ADDENDUM 2 – JOB 26

TO: All prospective bidders on project ITS-8-094(089)352 & SS-9-999(342), Job No. 26, scheduled for the October 9, 2015 bid opening.

2015 ESS & ATR IMPROVEMENT - EAST

Revised	9-30-15	STATE	PROJECT NO.	PCN	SECTION NO.	SHEET NO.
		ND	SS-9-999(342)	20949	1	1
				ITS-8-094(089)352	20970

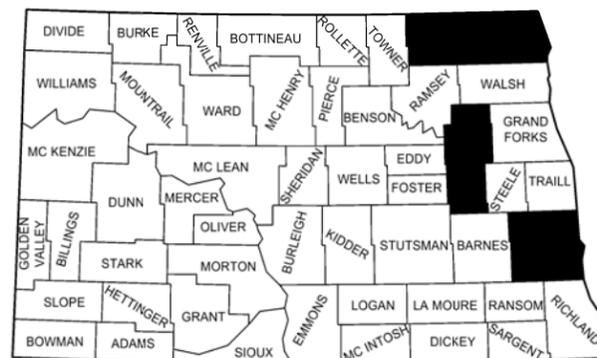
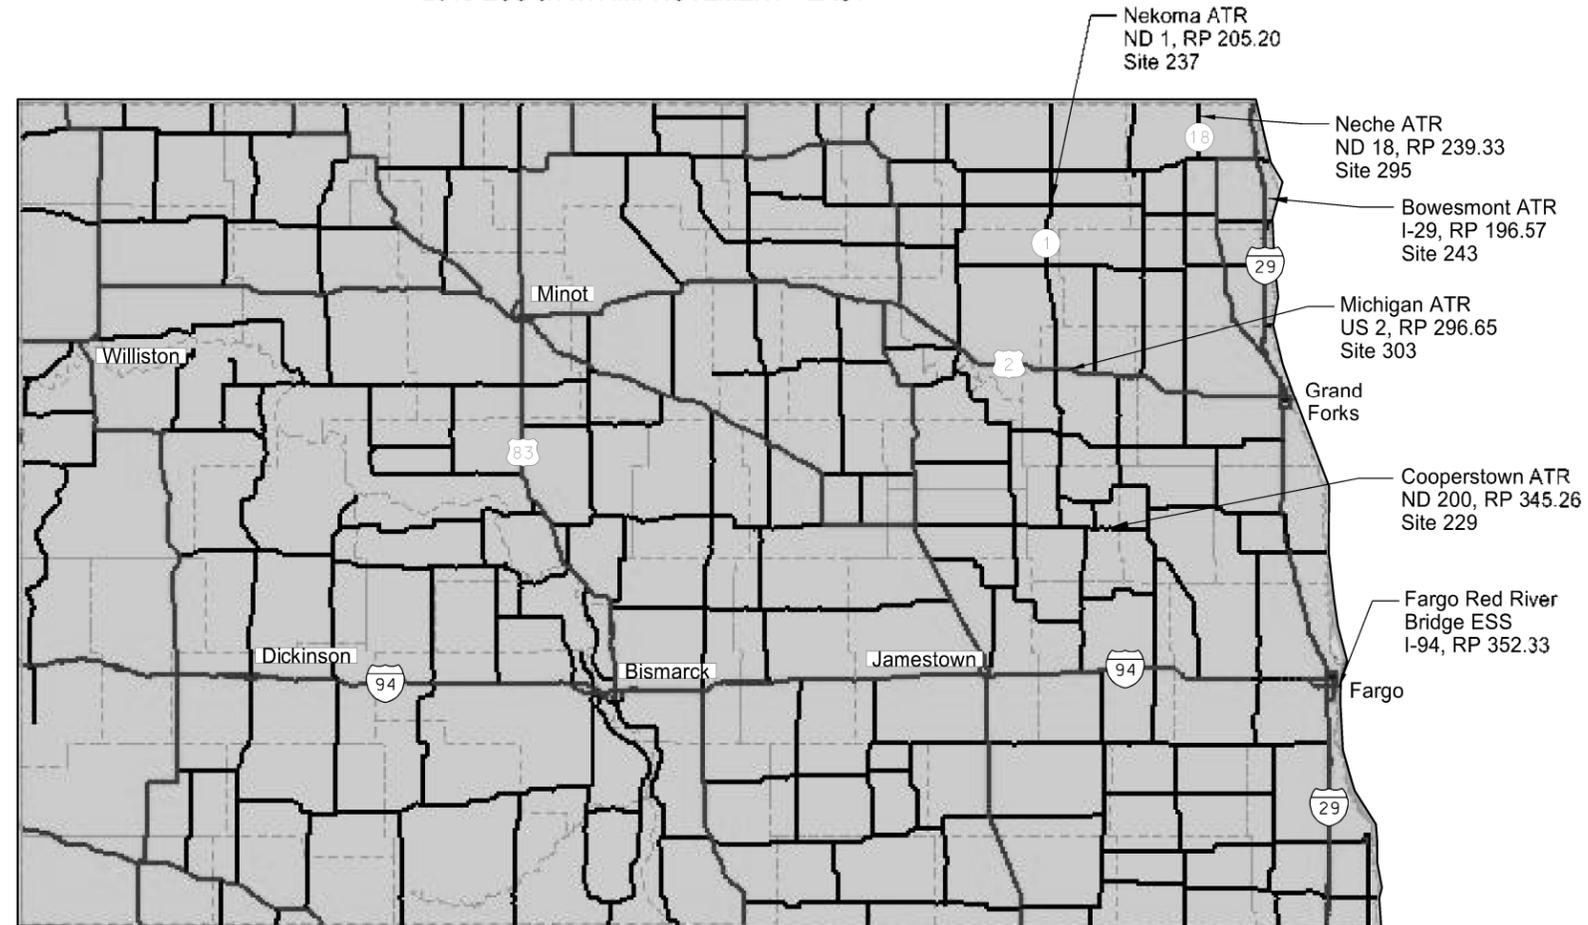
Sheet 1-1:

Two ATR sites were added, "Bowesmont ATR" and "Cooperstown ATR"

ATR Layout
 ND Hwy 200
 RP 345.26
 Site 229
 Cooperstown

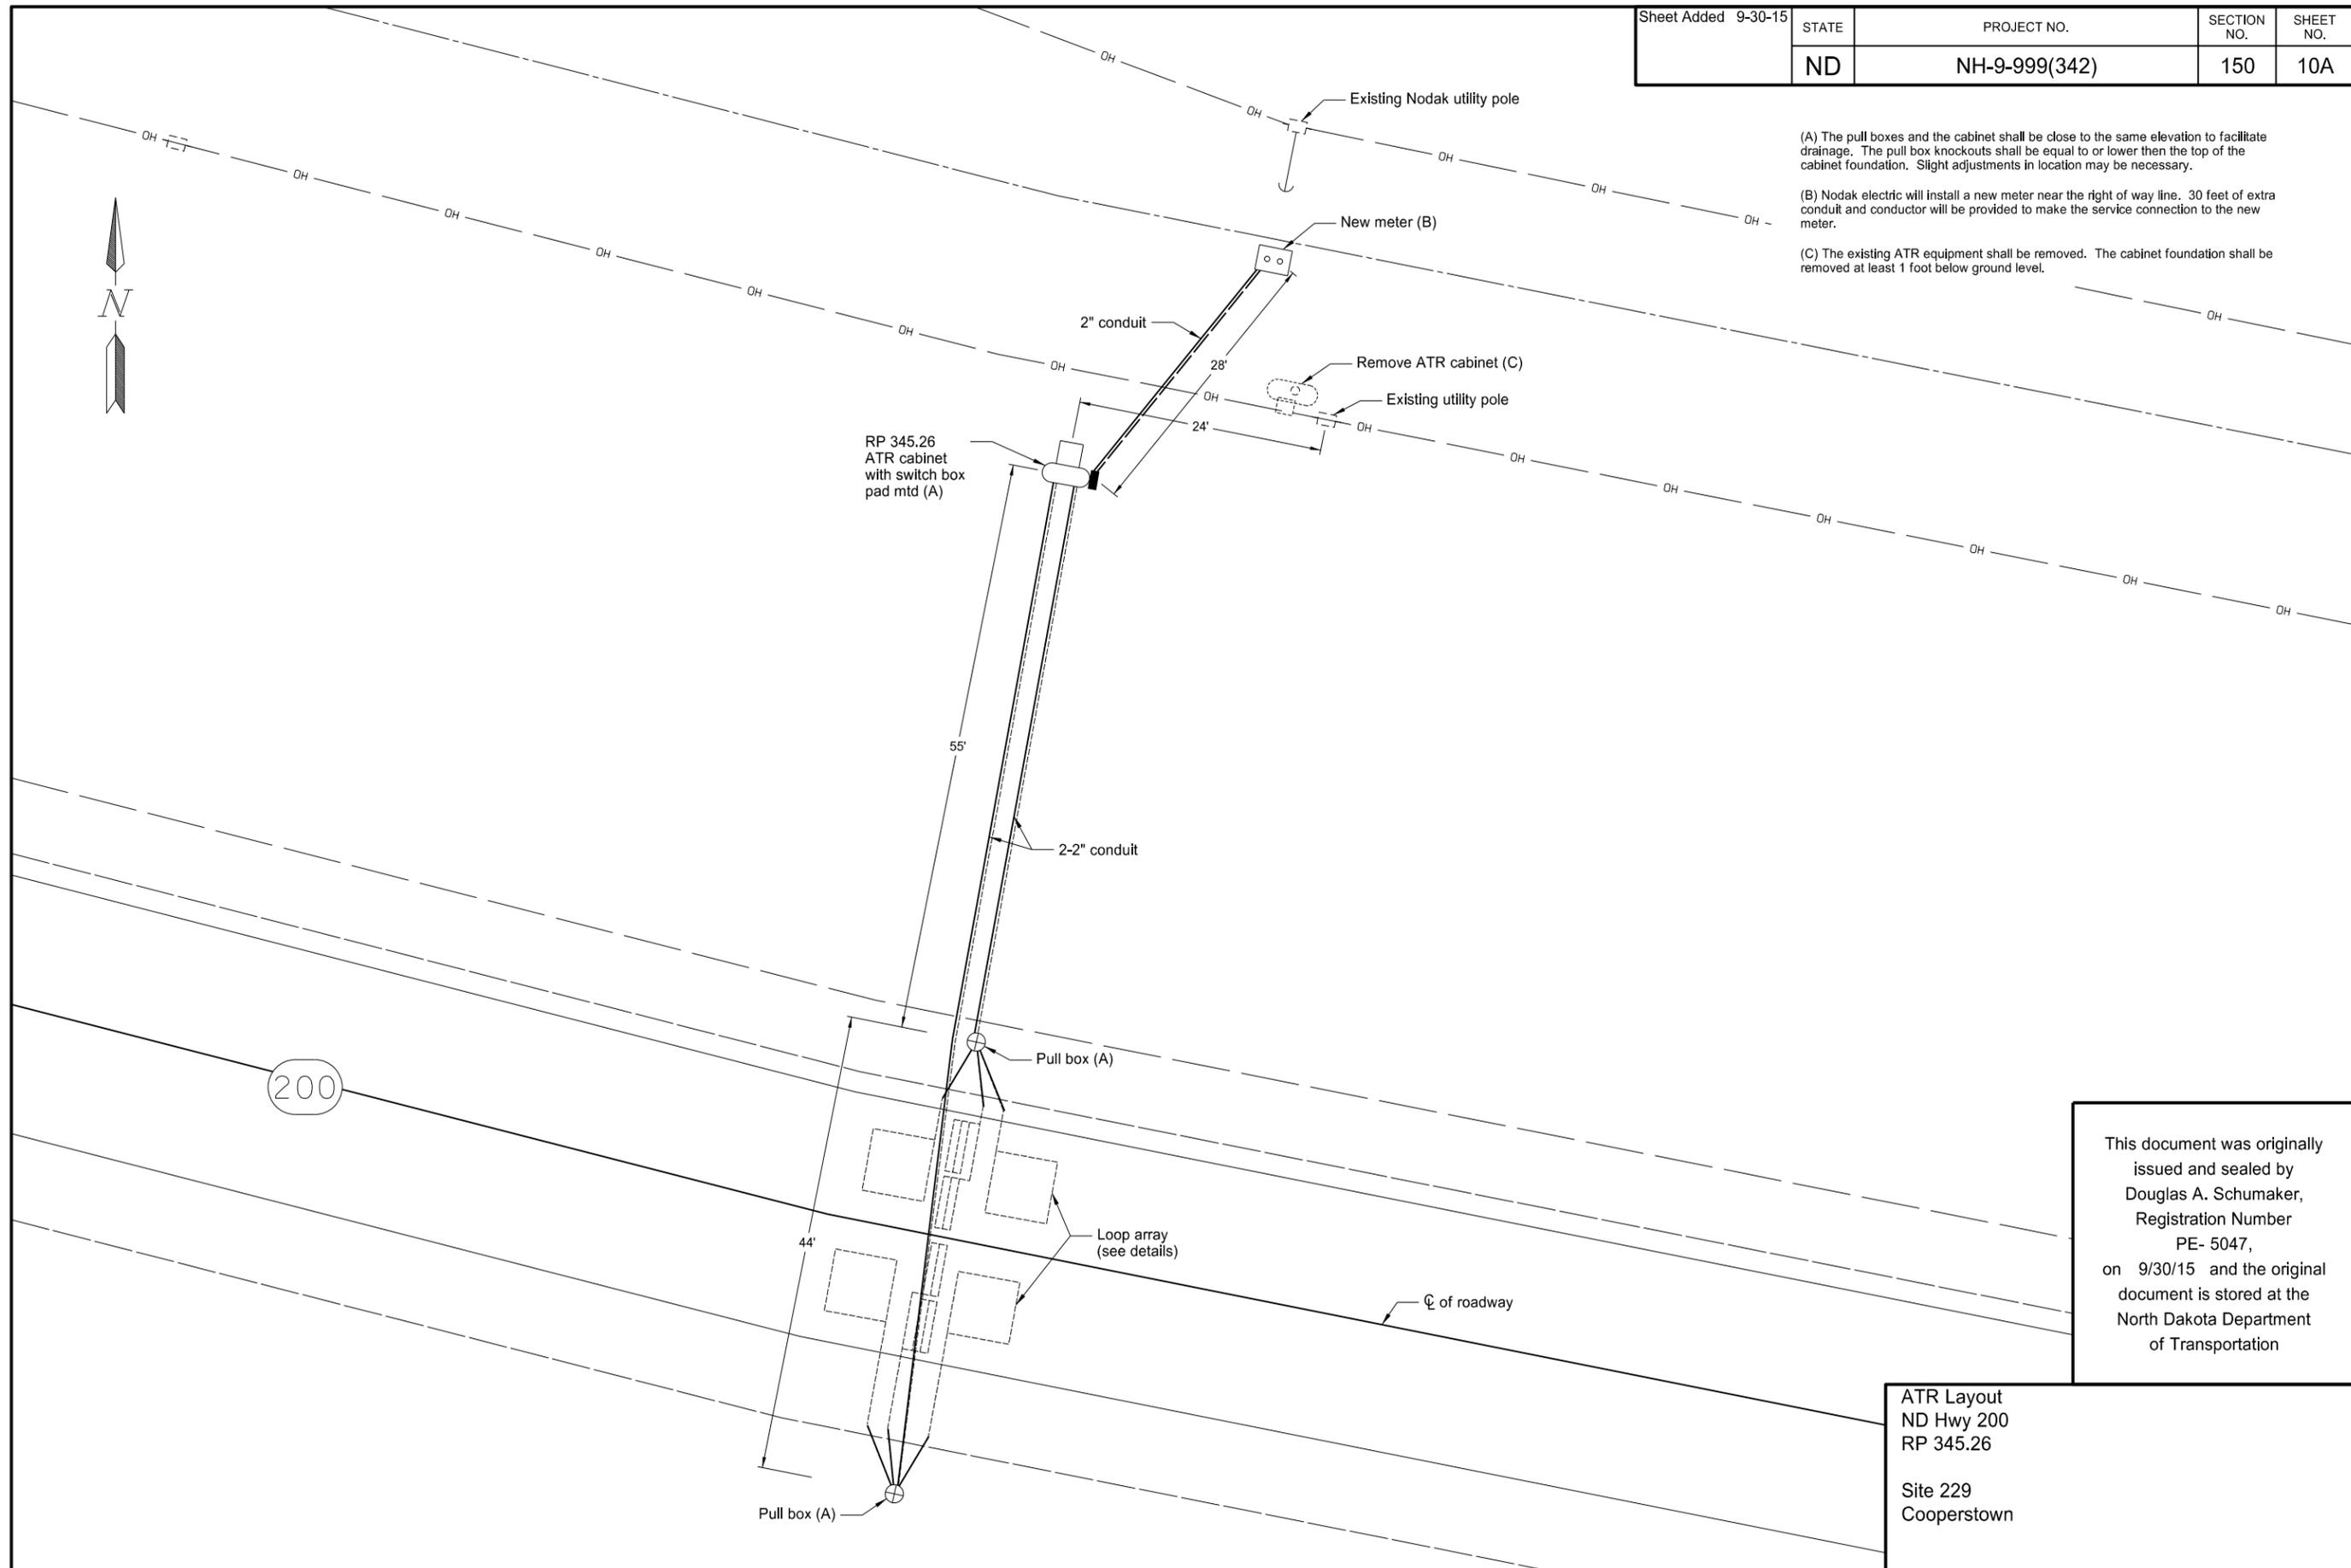
Sheets 150-10A through 10C:

ATR Site 229 near Cooperstown has been added. This is a new 2 lane ADR 6000 ATR site. The old ATR equipment will be removed. Detail sheet and quantities table are included.

- (A) The pull boxes and the cabinet shall be close to the same elevation to facilitate drainage. The pull box knockouts shall be equal to or lower than the top of the cabinet foundation. Slight adjustments in location may be necessary.
- (B) Nodak electric will install a new meter near the right of way line. 30 feet of extra conduit and conductor will be provided to make the service connection to the new meter.
- (C) The existing ATR equipment shall be removed. The cabinet foundation shall be removed at least 1 foot below ground level.

ATR Layout
I-29
RP 196.57

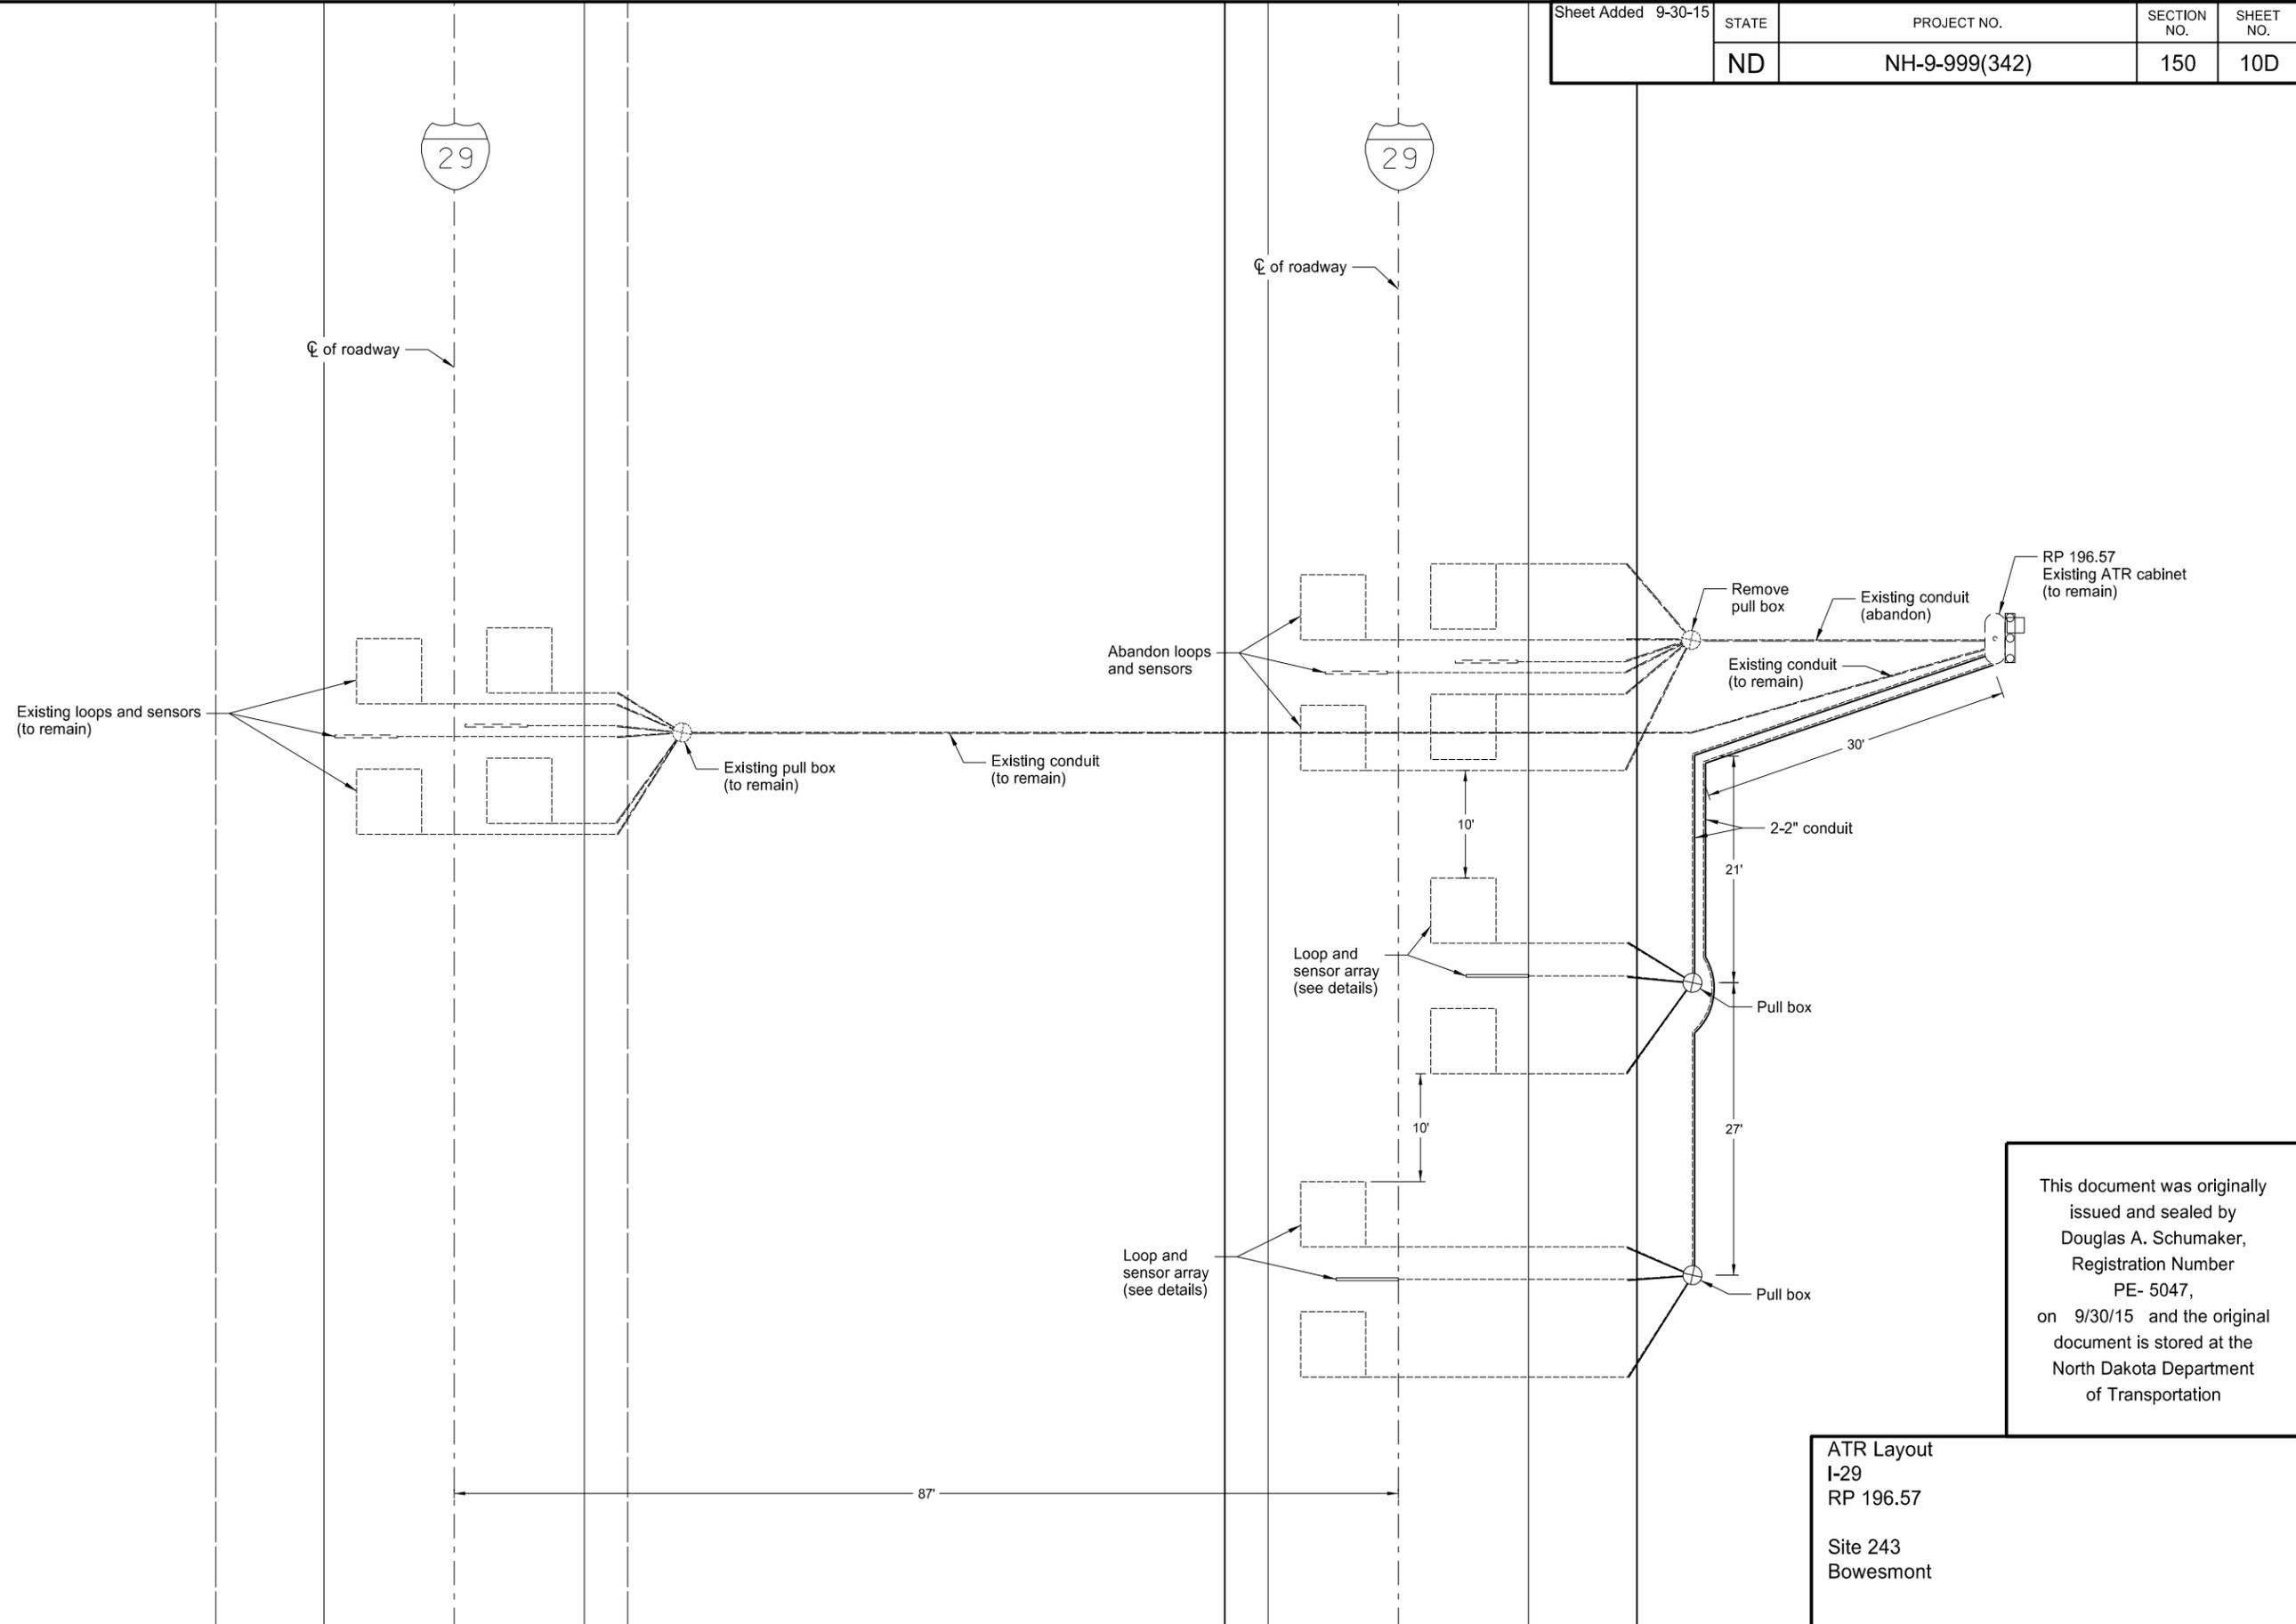
Sheets 150-10D through 10F:

ATR Site 243 near Bowesmont has been added. The existing ATR site requires new loops and sensors in the northbound lanes. Detail sheet and quantities table are included.
